Subject: Request for Proposal 2 - Changes to Backfill at Interior Retaining Walls

Project Name: Camden Rockport Middle School

Potential Change Order #007

Request for Proposal No. 002

| TITLE THIS DWG. FOUNDATION DETAILS 4 | | | |

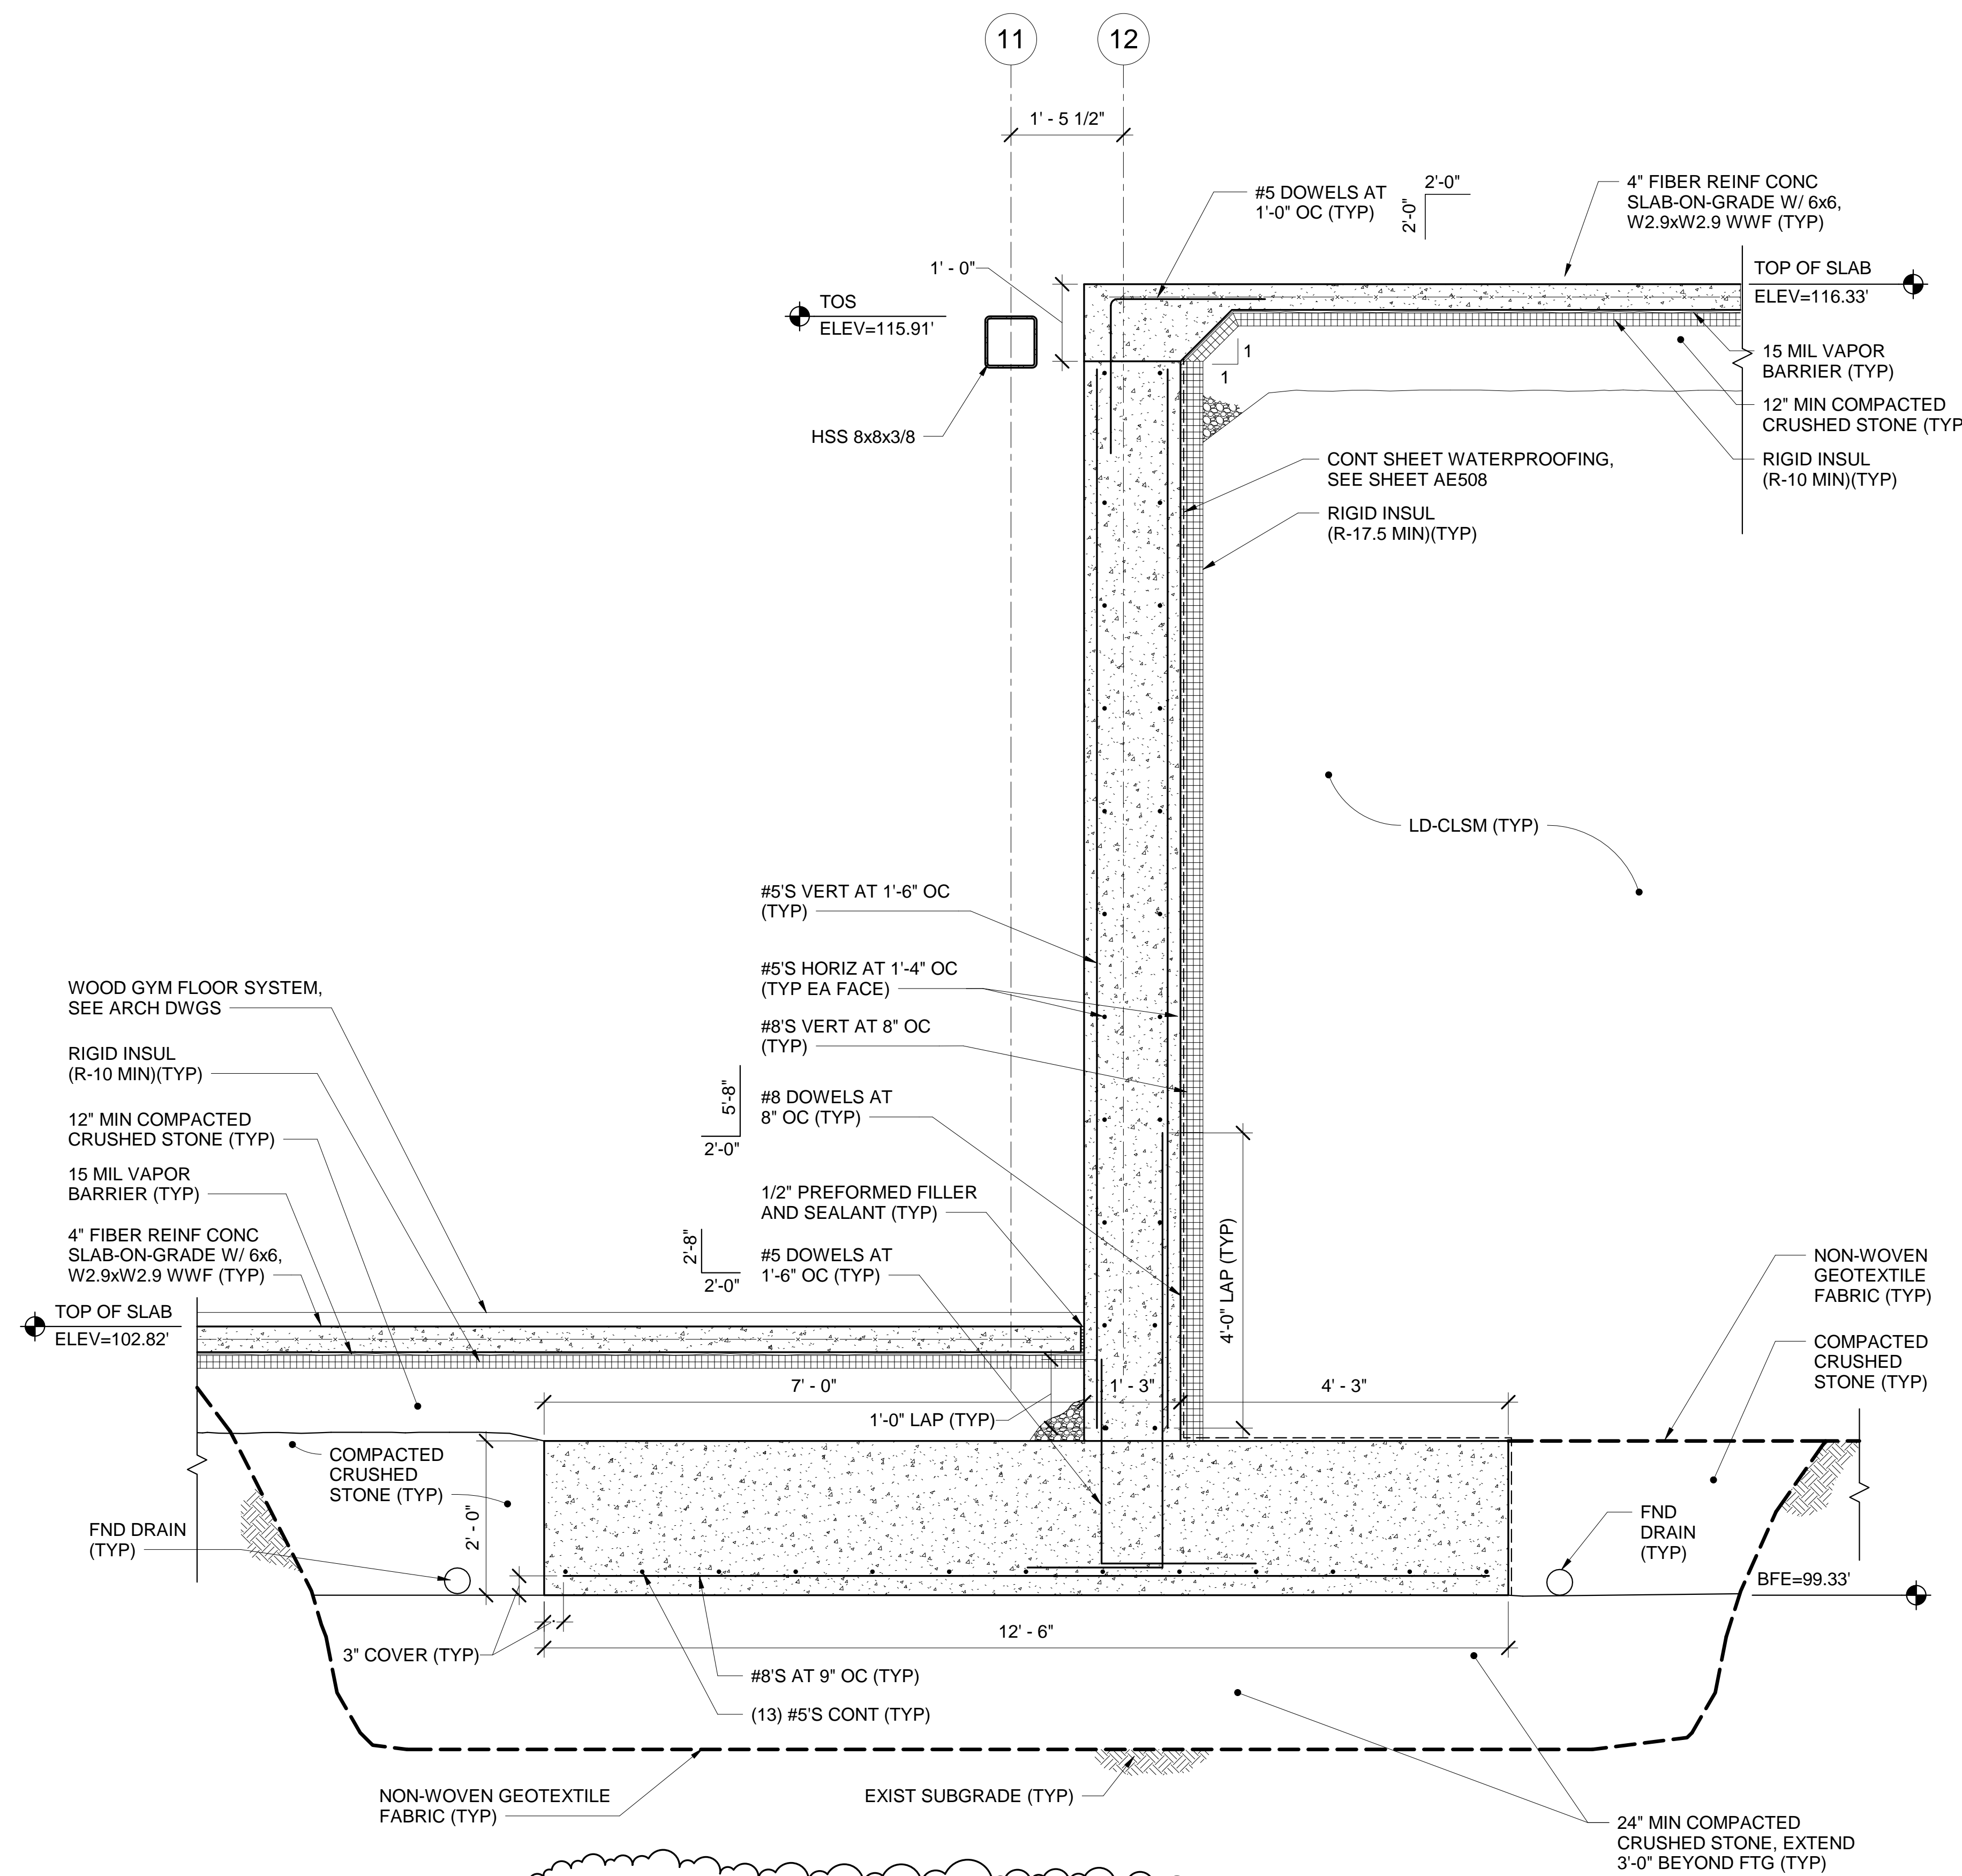
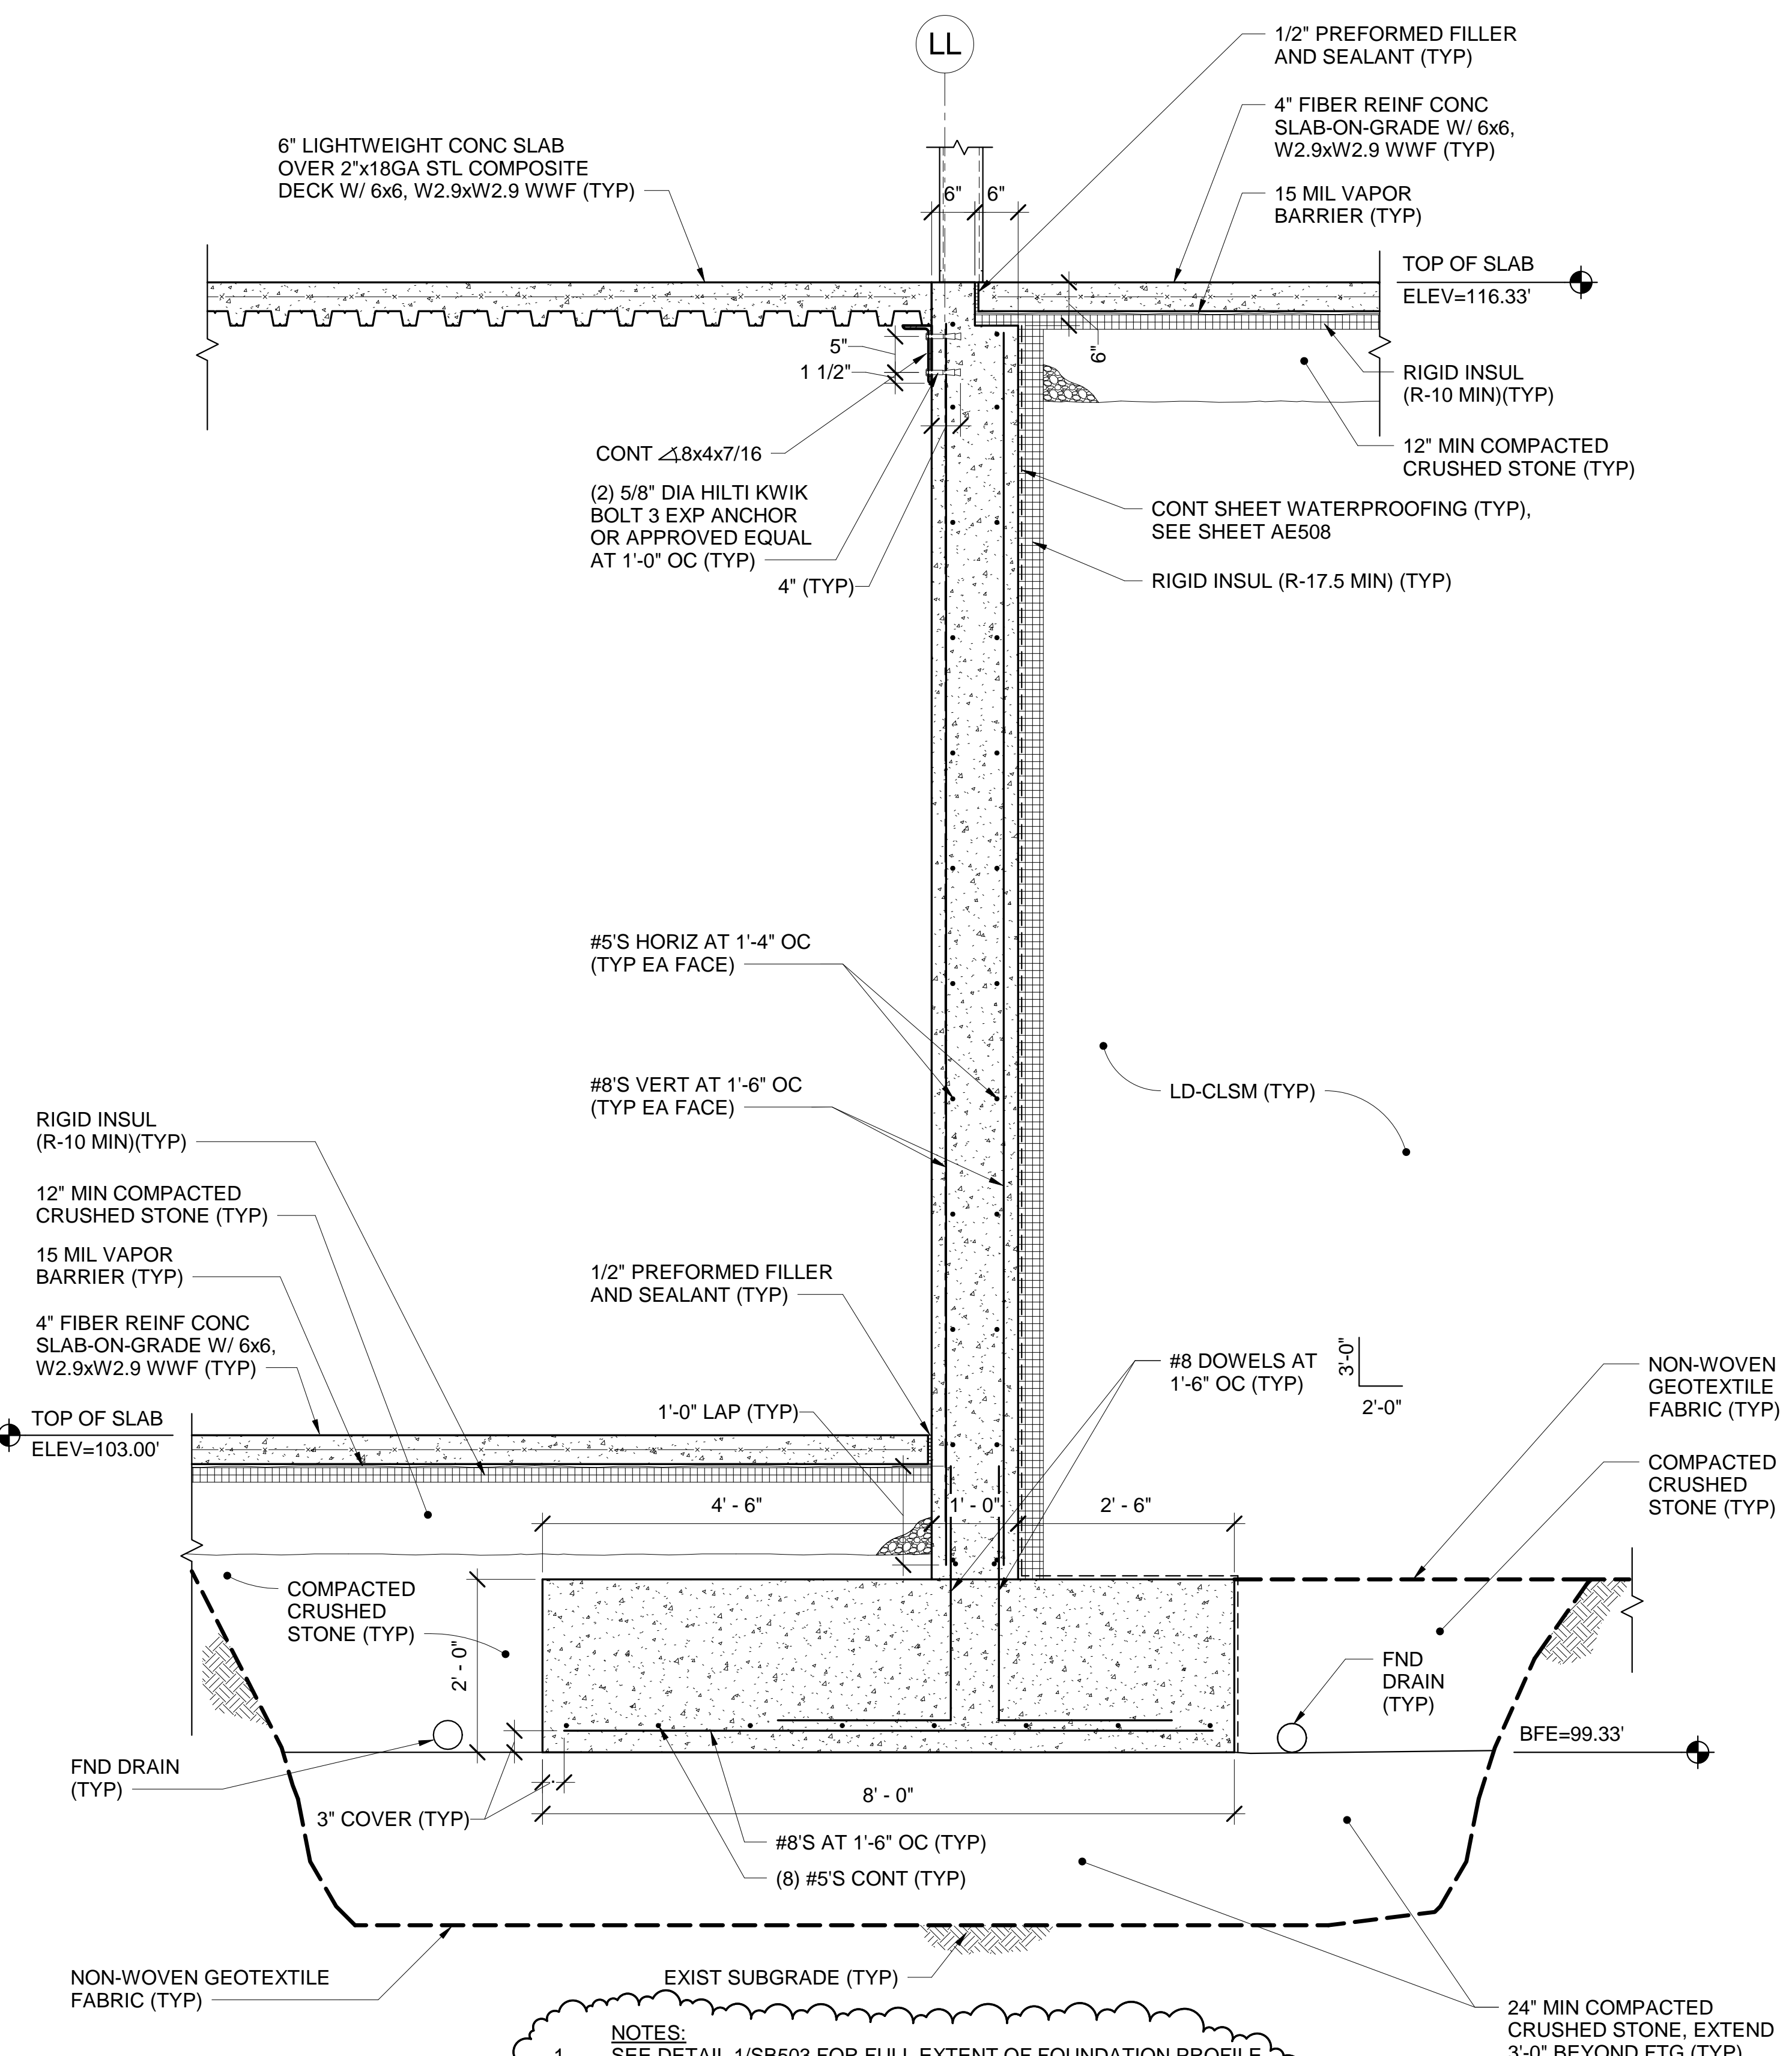
3. Revise reinforced concrete retaining wall indicated in detail 1/SB504.
4. Refer to attached drawings SB102 (**Revised 08-22-18**), SB503, SB503, SB504 and SB505 for modifications to foundation plans and details.
